工程指示 / 要求簡箋 ENGINEER INSTRUCTIONS(E.I.)

工程指示編號:	EI- 8930	修改版本:	-
	HK-		
工程編號:	J 859	工程名稱:	啟德6551
收件人:	生統	發件人:	細佬
工程項目:	玻璃加工圖	日期:	12/05/2025

內容: 請按附頁加工圖訂玻璃, 共一件玻璃 備注: 4月29號收到大判改一幅窗, 附件WhatsApp記錄和則師批圖(CS-2053)
完成上列要求日期: 02/06/2025

WINDOW MARK	W12/P T2 1 no.
LOCATION	SKY MANOR BR2 AT 20/F (T2)
GLAZING	G2
WINDOW FRAME	70mm ALUM. WINDOW SECTION

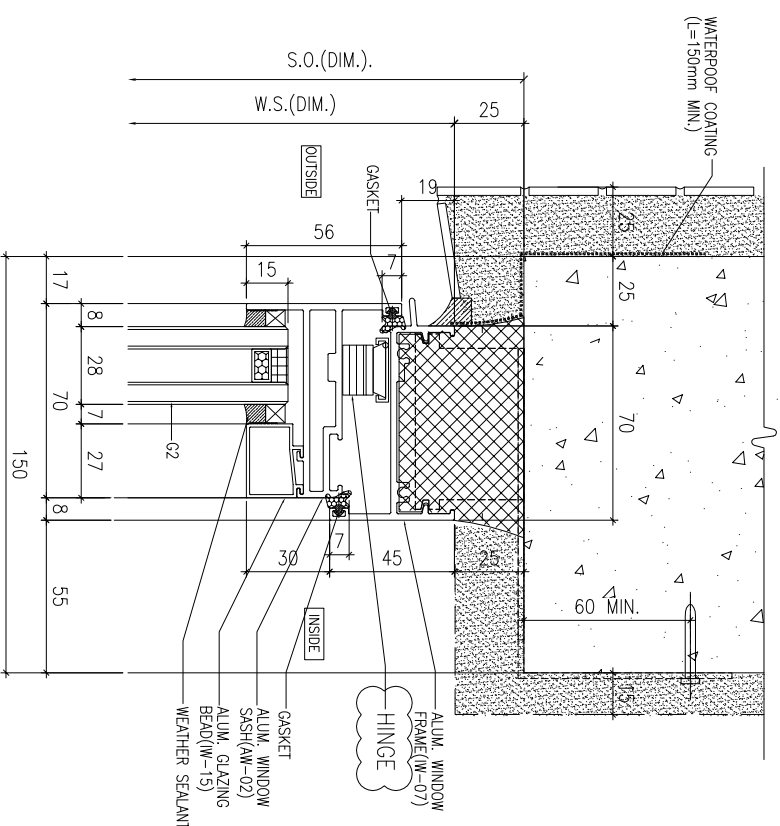
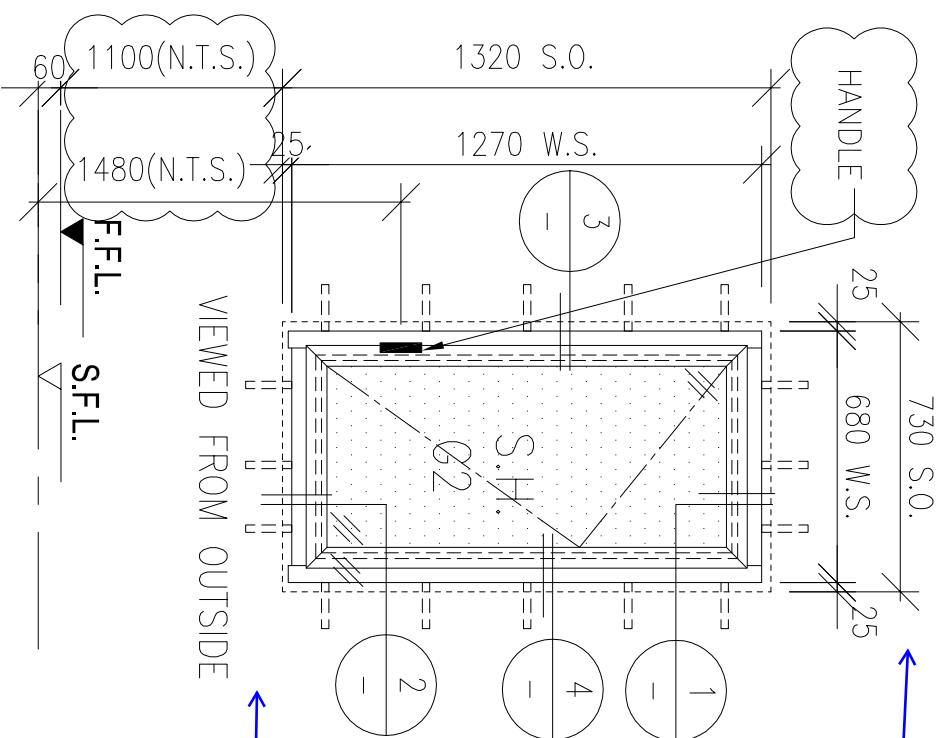
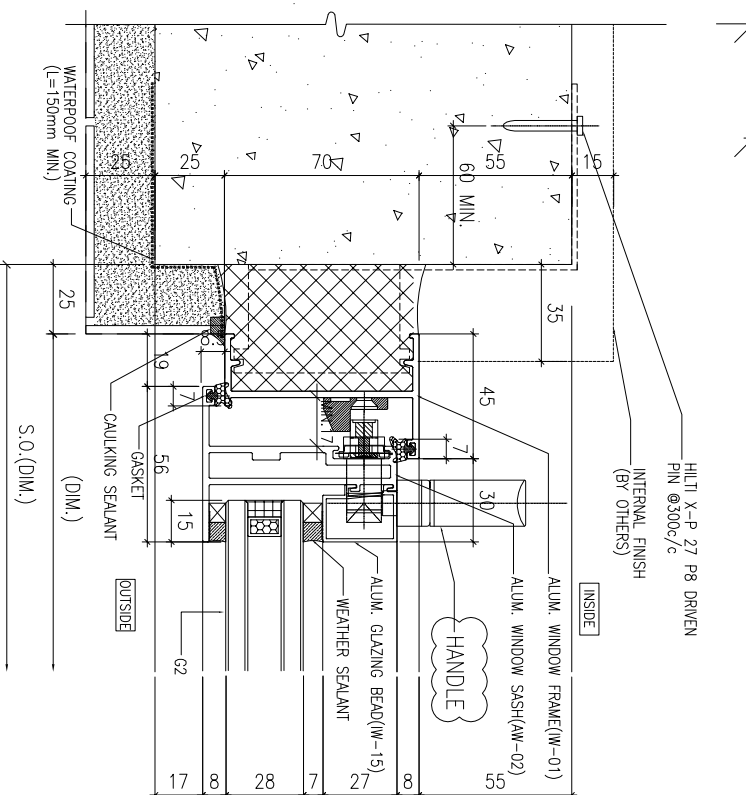
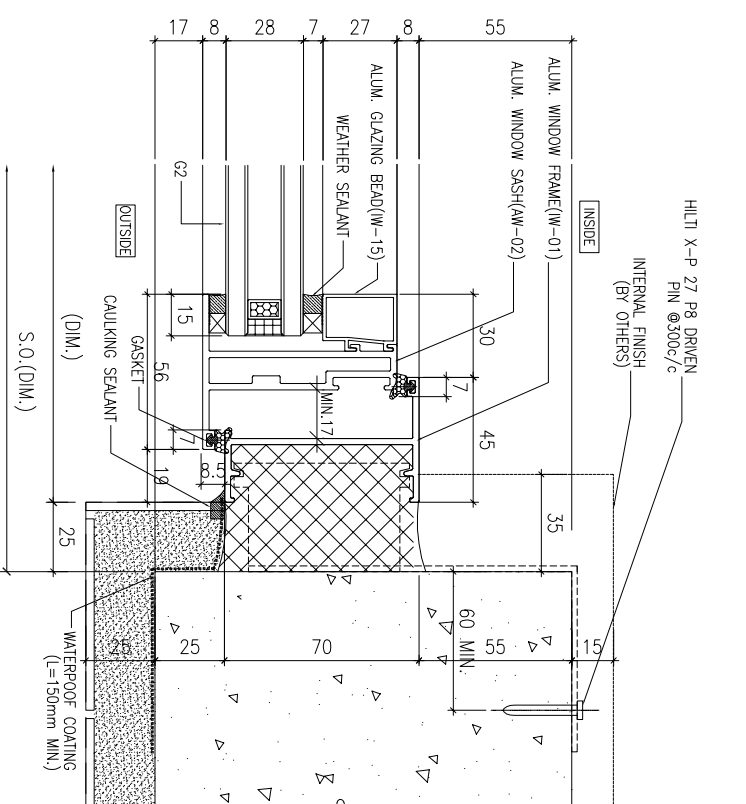
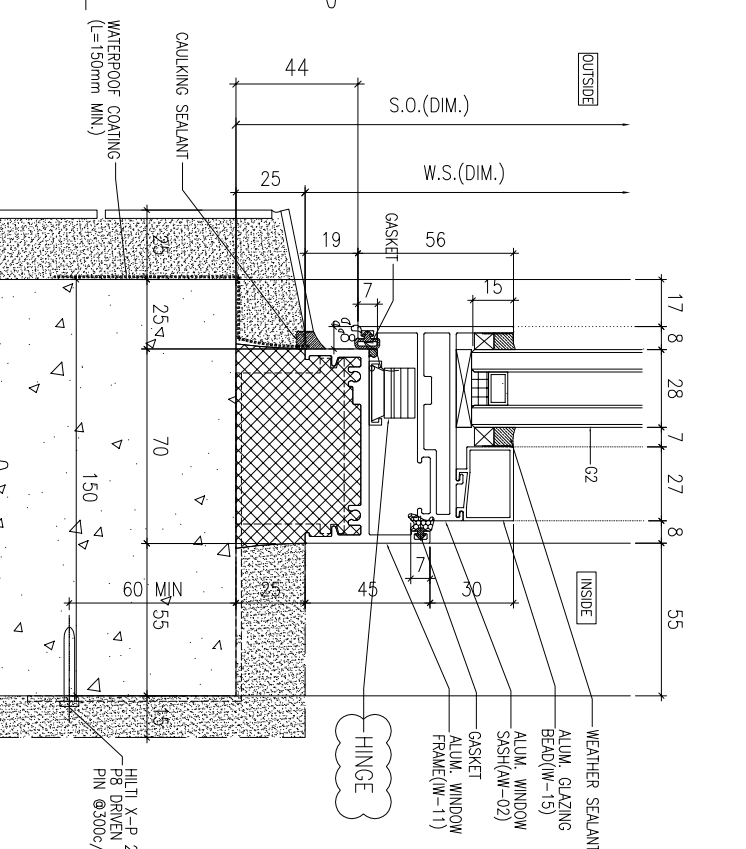
Exact S.O. to be verified on site

Ensure bottom of window opening to be min. 1100 A.F.F.L

WONG TUNG & PARTNERS LTD.	
APPROVED	<input checked="" type="checkbox"/>
APPROVED AS NOTED	<input type="checkbox"/>
APPROVED AS NOTED & RESUBMIT	<input type="checkbox"/>
RESUBMIT	<input type="checkbox"/>
NO COMMENT	<input type="checkbox"/>
REFER OTHER CONSULTANTS COMMENTS	<input type="checkbox"/>

20/F WINDOW LOCATION PLAN
FOR PRECAST FACADE AT TOWER 2

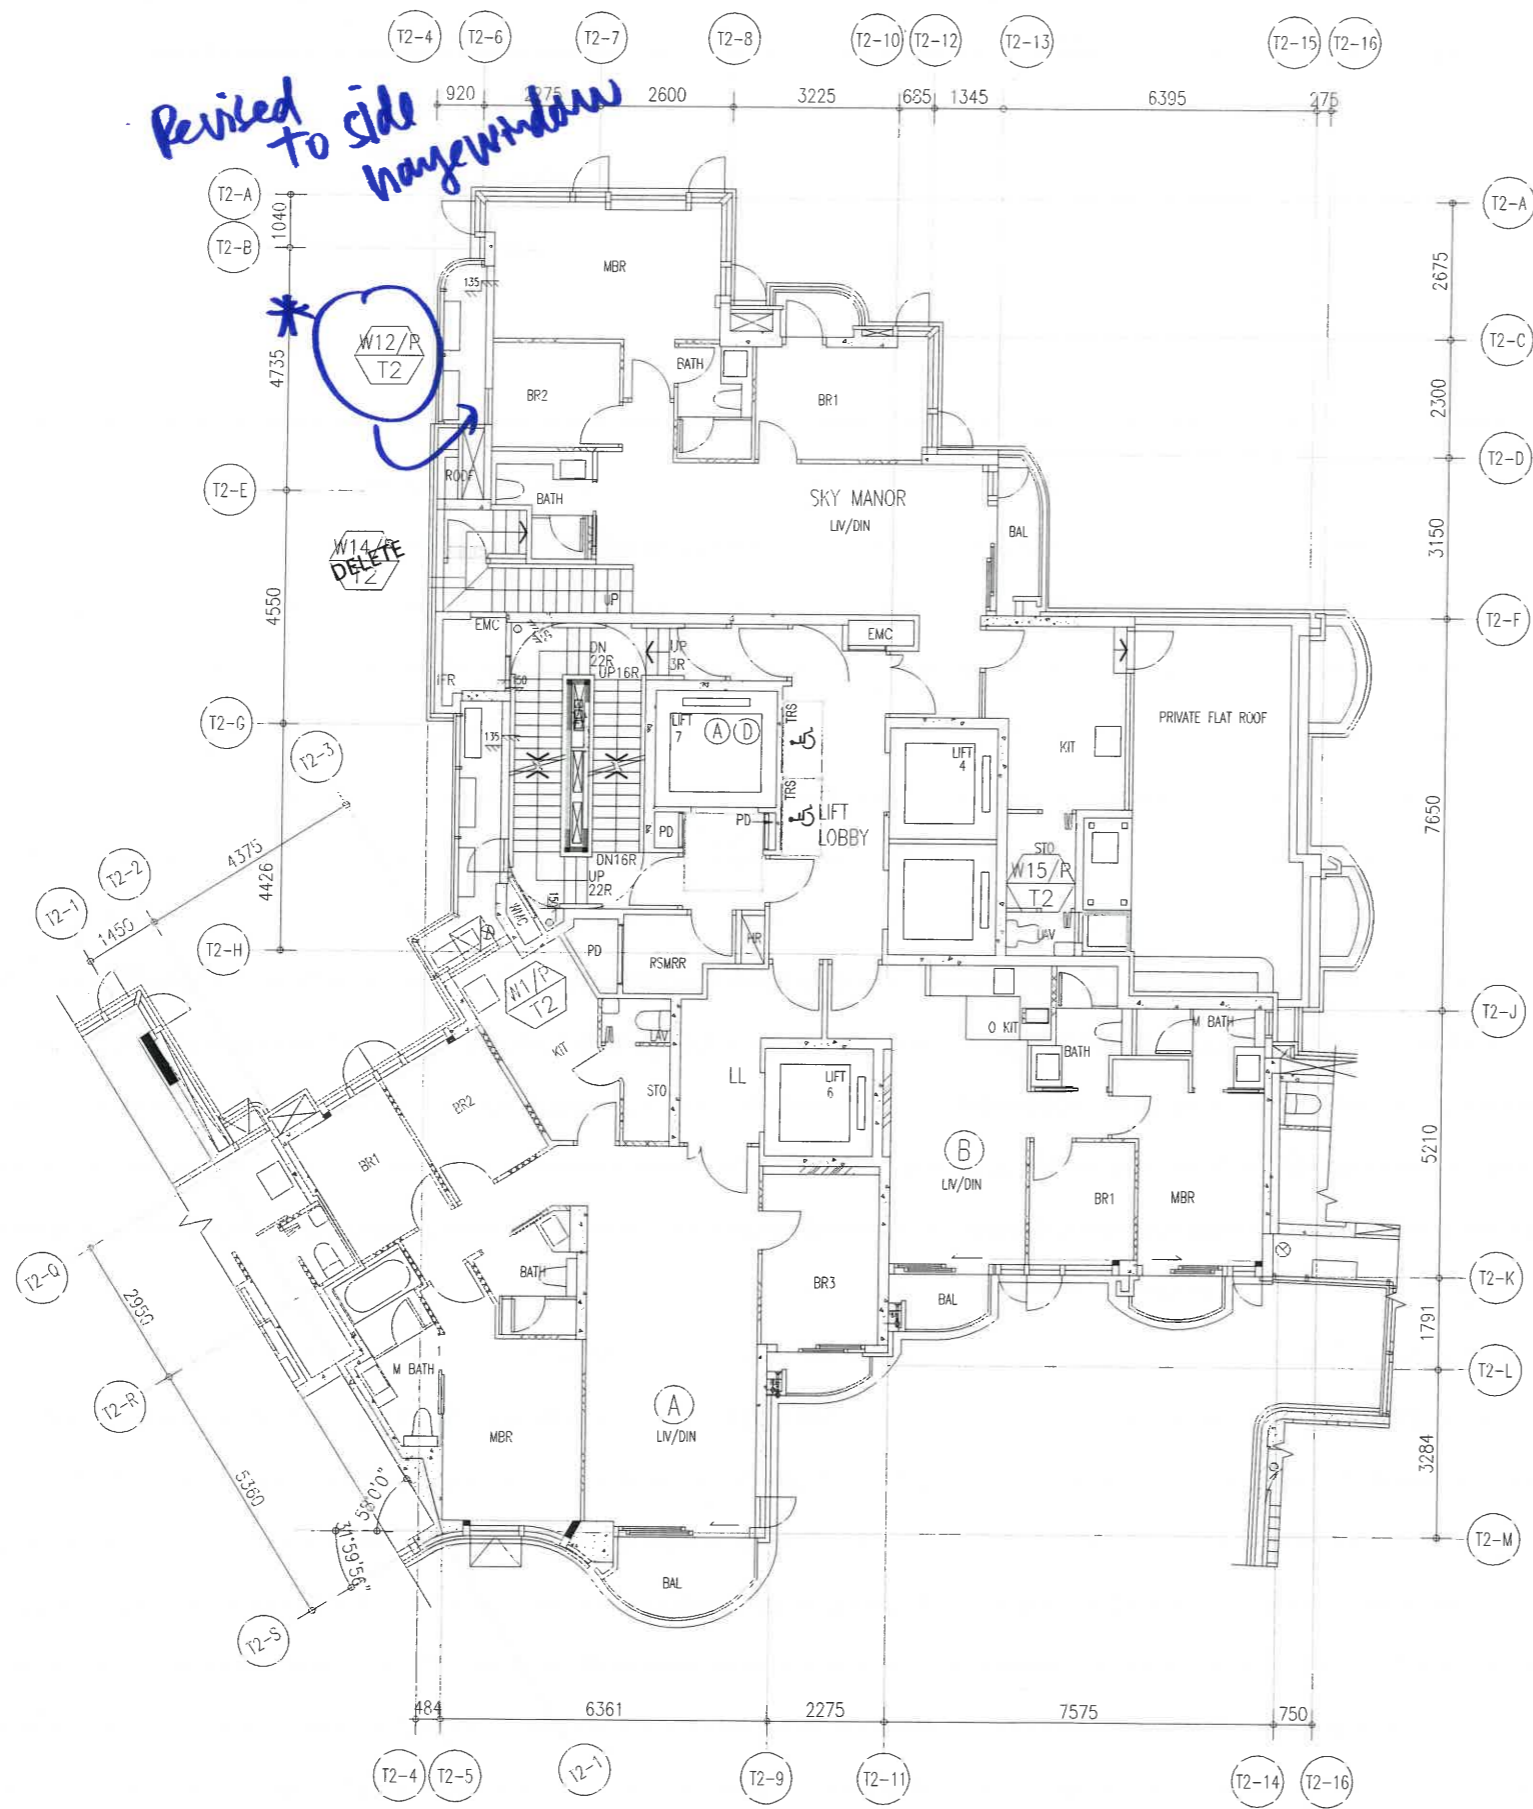
Revised to side bay window

4 VERTICAL DETAIL

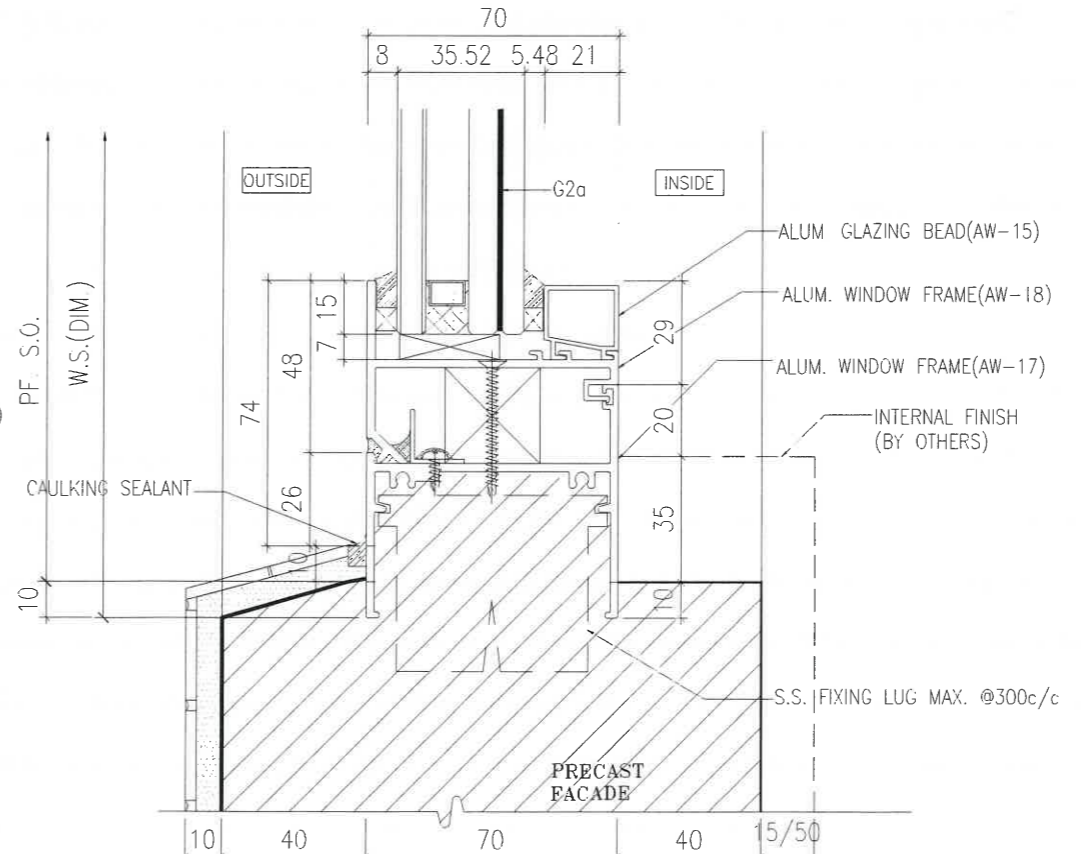
DELETE
CHANGE TO
DT83a-4
